UNITED STATES PATENT AND TRADEMARK OFFICE

APPLICATION NO.	FILING DATE	FIRST NAMED INVENTOR	ATTORNEY DOCKET NO.	CONFIRMATION NO.
10/752,208	01/06/2004	Irving Sabo	2258.002	2638

Office Action Summary	Application No. 10/752,208	Applicant(s) SABO ET AL.	
	Examiner Philip Gabler	Art Unit 3637

DETAILED ACTION

Exhibit 1: Brown '114 Figures 1 and 2

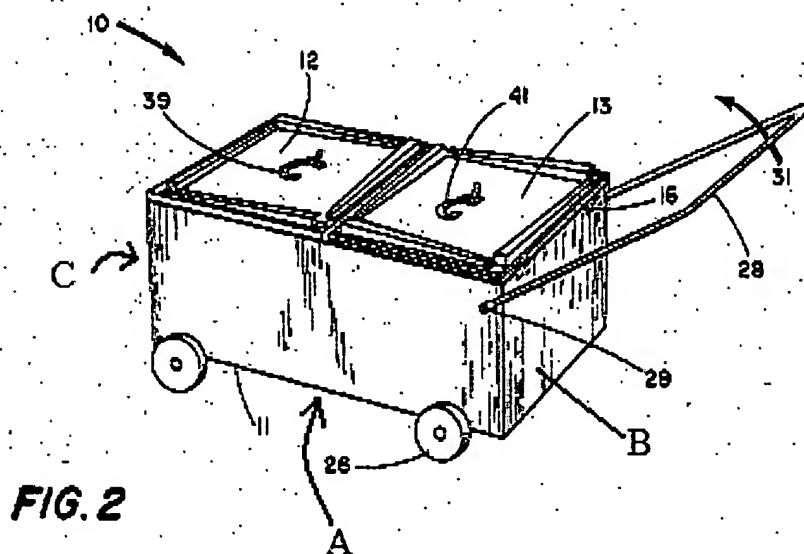
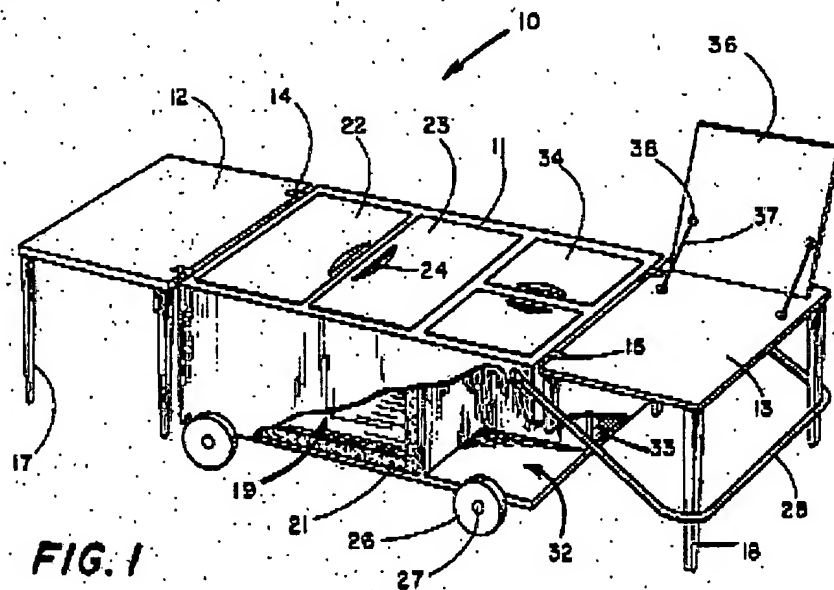
2. Claims 1-10, 32, and 33 are rejected under 35 U.S.C. 102(b) as being anticipated by Brown (US Patent Number 3873114). Brown (Figures 1 and 2) discloses a storage container comprising: an enclosure (11) having an open top (covered in Brown's figures), a bottom (viewed as A in Exhibit 1), a first end (B), and a second end (C) opposite the first end; a first lid (13) pivotally mounted to the first end, the first lid adapted to cover at least some of the open top; and at least one second lid (23) detachably mounted (as evident by the handle for allowing manipulation of the lid to gain access to the container) between the first end and the second end, the second lid adapted to cover at least some of the open top.

3. Regarding claim 2, Brown further discloses a third lid (12) pivotally mounted to the second end (C), the third lid adapted to cover at least some of the open top.

4. Regarding claim 3, Brown further discloses a first end comprising a first end panel (also viewed as B) and wherein the first lid is pivotally mounted to the first end panel.

6. Regarding claim 5, Brown further discloses the first lid adaptable to be pivotally mounted into a horizontal position outside the open top of the enclosure (see Brown's Figure 1).

7. Regarding claim 6, Brown further discloses at least one of the first lid and the third lid is adapted to be pivotally mounted into a horizontal position outside the open top of the enclosure (see Brown's Figure 1).

8. Regarding claim 7, Brown further discloses the first lid is adapted to be pivotally mounted in a vertical position outside the open top of the enclosure (not only does the lid swing through a first vertical position between its closed and open horizontal positions, but, with the legs folded, it could continue to a second, downward, vertical position along the end of the container).

21. Regarding the ability of the first and third covers to be pivotally mounted in a vertical position of claim 7, in moving from their positions shown in Brown's Figure 1 to those of Figure 2, the covers would necessarily be disposed in a vertical position. While this position may be different than the vertical position intended by Applicant for his covers, it fully meets the limitations set forth in claim 7.

22. Regarding the suggestion that the second lid (Brown's 23) does not cover the open top of the enclosure, this is simply not the case. The lid/cover is intended to cover/enclose the open top of the enclosure, while the first and third lids (Brown's 12 and 13) further cover the open top of the enclosure (forming a second layer above second lid 23) clearly meeting the limitation of claim 8.

Primas '399 Figures 9, 11, and 12

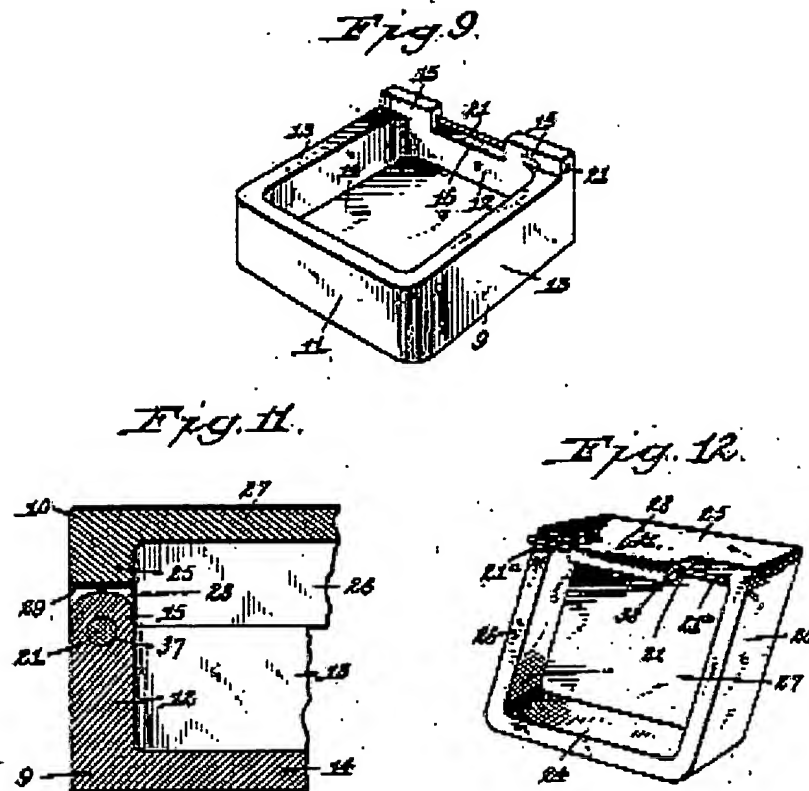
15. Claims 21-30 are rejected under 35 U.S.C. 103(a) as being unpatentable over Brown in view of Primas (US Patent Number 2200399). Brown discloses a hinge assembly (16) for use with a storage container having a lid and an end panel wherein the hinge assembly is adapted to allow rotation of the lid about an axis. Brown does not disclose a lid having a through hole, a hinge block having a through hole or a circular rod. Primas (Figures 9, 11, and 12) discloses a container with a lid (10) with a through hole (38) pivotally mounted to a housing (9) by a hinge assembly comprising: at least one hinge block (15) having a through hole (37); and a circular rod (21) adapted to engage the through hole in the block and lid, the circular rod having an axis (along length of 21); wherein the hinge assembly is adapted to allow rotation of the lid about the axis of the circular rod. Accordingly, it would have been obvious to one of ordinary skill in the art at the time the invention was made to modify Brown's hinge assembly as taught by Primas to use a lid and a hinge block with a through hole connected by a circular rod because this would provide a sturdy, simple hinge design.

17. Regarding claims 29 and 30, Brown, when modified by Primas as described above, discloses a storage container as recited in claim 21. Primas further discloses a hinge assembly wherein the at least one hinge block comprises at least two hinge blocks (two features 15) and a container lid comprising at least one notch (the gaps on either side of 28) wherein the at least one hinge block is adapted to engage the at least one notch. Accordingly, it would have been obvious to one of ordinary skill in the art at the time the invention was made to further modify Brown's hinge assembly as taught by Primas to use a hinge assembly with at least two hinge blocks and a lid with notches to engage these hinge blocks because this arrangement would provide Brown's container with an effective hinge design that remains simple to manufacture.

24. Regarding the arguments relating to the 35 USC 103 rejections citing Brown in view of Primas, it is irrelevant whether Primas's invention meets the rotation limitations of claims 23 and 24 as Primas is used simply as a teaching reference showing the specific structure of a hinge used to modify Brown's hinge (of which Brown discloses little structurally). Brown's use of a slightly modified hinge would not prevent his structure from meeting the claimed limitations as described in the rejections.

Branz et al. '859 Figure 1A

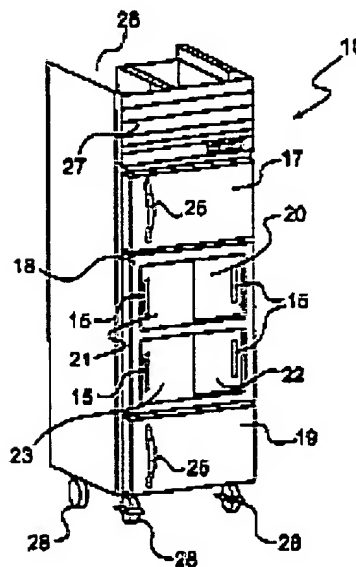
18. Claim 31 is rejected under 35 U.S.C. 103(a) as being unpatentable over Brown in view of Branz et al. (US Patent Number 6467859). Brown discloses a container as recited in claim 1 but does not disclose a slidably mounted lid. Branz (Figure 1A) discloses a storage container (10) with a slidably mounted lid (21). Accordingly, it would have been obvious to one of ordinary skill in the art at the time the invention was made to modify Brown's second lid to be slidably mounted as taught by Branz because this could allow for better temperature control of the enclosure.
